Access Compliance Report Public Rights-of-Way (Curb Ramps)

Main Street: ERVIN_LN Cross Street: HEWES_AVE Location: SE

ADA ID: RPAT211026132330 Ramp Type: Type 4 - Parallel Initial Pass/Fail: Fail Overall Compliance: No Severity Score: 4

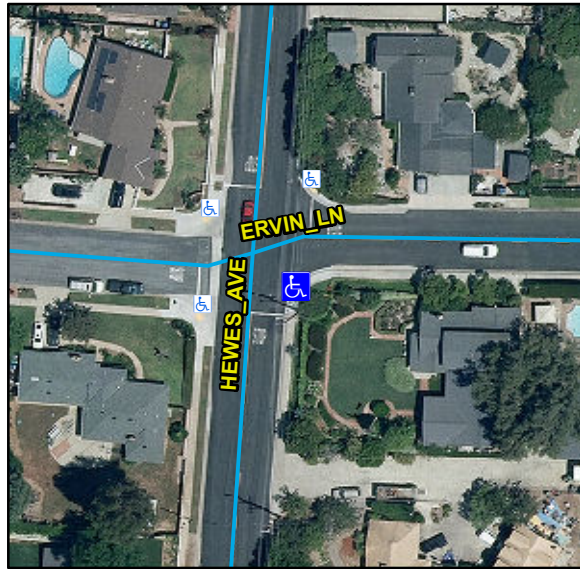
Compliance	Description	Data	Compliance	Description	Data
N/A	Ramp Length LT (in)	83	N/A	Ramp Length RT (in)	82
No	Ramp Width LT (in)	45	No	Ramp Width RT (in)	47
Yes	Ramp Run Slope LT (%)	7.5	Yes	Ramp Run Slope RT (%)	5
Yes	Ramp Cross Slope LT (%)	0.2	Yes	Ramp Cross Slope RT (%)	0.4
N/A	Landing Present	N/A	N/A	DWS Provided	N/A
N/A	Landing Length (in)	N/A	N/A	DWS Contrast	N/A
N/A	Landing Width (in)	N/A	N/A	DWS Length (in)	N/A
N/A	Landing Run Slope (%)	N/A	N/A	DWS Full Width	N/A
N/A	Landing Cross Slope (%)	N/A		DWS Offset Type	N/A
N/A	Landing Movement Obstructed?	N/A	N/A	DWS Offset Left (in)	N/A
	Landing Movement Type	N/A	N/A	DWS Offset Right (in)	N/A
N/A	Landing Shared	N/A			
N/A	Clear Space	Yes			
N/A	Clear Space To Crosswalk (in)	N/A			
N/A	Marked Crosswalk 1	No	N/A	Marked Crosswalk 2	No
	Crossing 1 Direction	NE		Crossing 2 Direction	NW
	Marked Crosswalk 1 Width (in)	N/A		Marked Crosswalk 2 Width (in)	N/A
N/A	Ramp Inside Crosswalk 1	N/A	N/A	Ramp Inside Crosswalk 2	N/A

Remove & Replace Curb Ramp With Two New Directional Ramps or Equivalent.
